# **Draft Branch Technical Position on Concentration Averaging and Encapsulation, Revision 1**

**U.S. Nuclear Regulatory Commission**

**May 2012**

Figure 1. Classification of Mixtures of Activated Metals, Contaminated Materials and Cartridge Filters

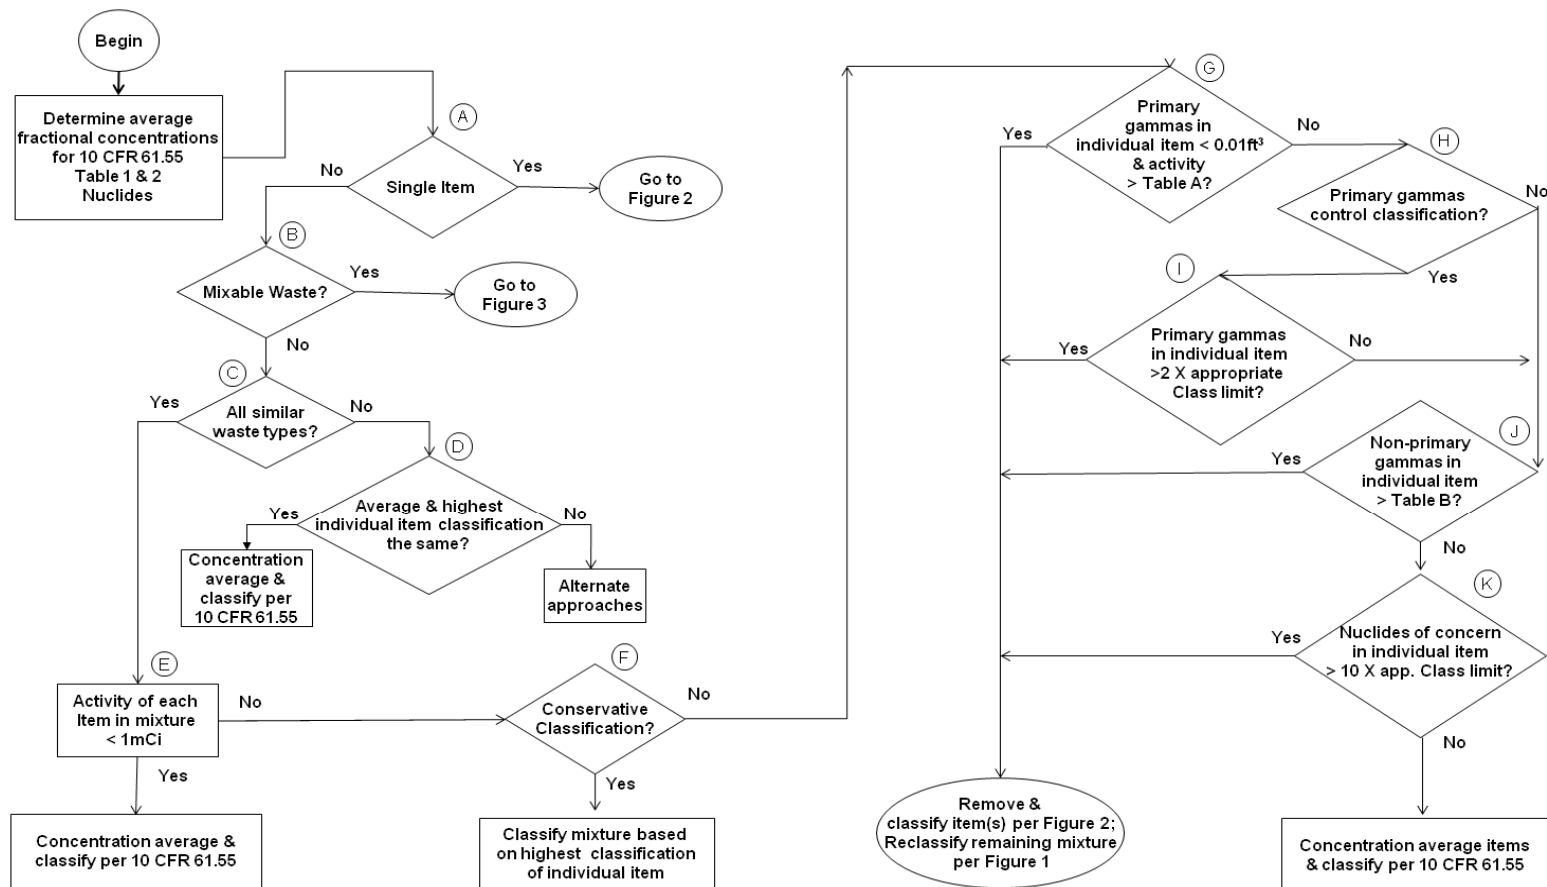
- a. Larger sealed source owners will benefit from the new guidance, and not disposal States. CAE BTP Figure 1 flowchart shows how “coffee cup” sized items with certain activity levels are separated from the waste form, and then undergo another series of tests. In turn, the NRC Figure 2 tests allow “coffee cup” sized items to be diluted by encapsulation and averaging over a larger volume container. This dilution provides a potential for generators to segregate small items with elevated activity and down-grade their classification. Taken to an extreme, GTCC equivalent material could be downgraded to Class C, or Class B/C equivalent materials could become Class A. This potentially would benefit generators with GTCC sources or who are mandated by law to manage GTCC waste.

- a. The NRC flowchart (CAE BTP Figure 1) outlines the new classification process, and shows the least scrutiny is given LLRW that is homogeneous and of similar type. Spent ion exchange resins at nuclear power plants certainly meet these criteria. As a result, generator States with nuclear power plants have a more streamlined process and will benefit more than other LLRW generators.

- a. Alternative approaches off-ramp provided on NRC Figure 1, allows a generator to classify waste on the basis of the disposal site's performance assessment (PA) model analysis (also see CAE BTP pp. 20-23). This is a direct benefit to generators, in that provides an "off-ramp" for generators to avoid following the proposed classification criteria on NRC Figures 1 and 2. It also opens the door for variability in its application on a State-by-State basis.
